Date	15 avril 2014
I ( )MIAT	Safety warning! n°2014/01/E2-E2L

# Reserve parachute handles for the EVO XC2, SKYPPER, SHAMANE and SHA-MANE FR

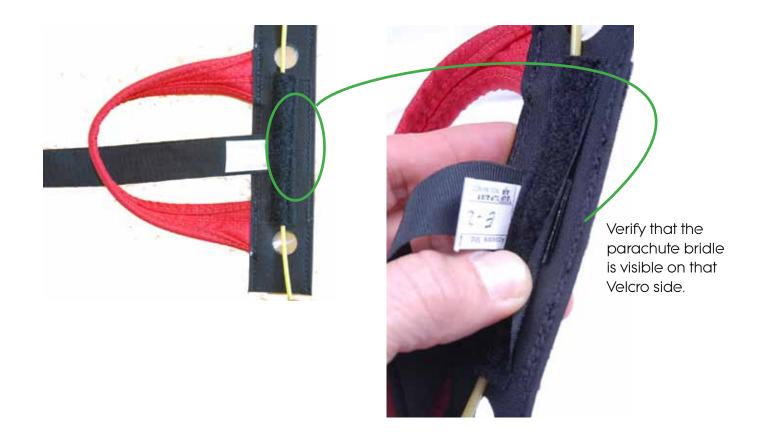
It was brought to our attention that a few reserve parachute deployment handles equipping the following harness models: SKYPPER, EVO XC2, SHAMANE and SHAMANE FR had a manufacturing defect.

In this case the pulling resisting force is reduced from 100 DaN to 40 DaN which is not enough anymore to conform to the certification norm.

It is possible in specific instances, to experience a reserve parachute handle bridle failure during the extraction sequence.

The bridle connecting the handle to the POD must be held in place with the Velcro strip two stitched lines.

A few handles were assembled without the bridle reaching the second stitched line. To check the handle, you must look underneath the Velcro strip and see if it is visible under the stitched line.

If the handle conforms then, reposition it has it initially was.

If the handle does not conform: you must contact your nearest SUPAIR dealer, or SUPAIR representative in your country, or SUPAIR-France directly, at sav@supair.com to proceed with the free of charge reserve parachute handle replacement.
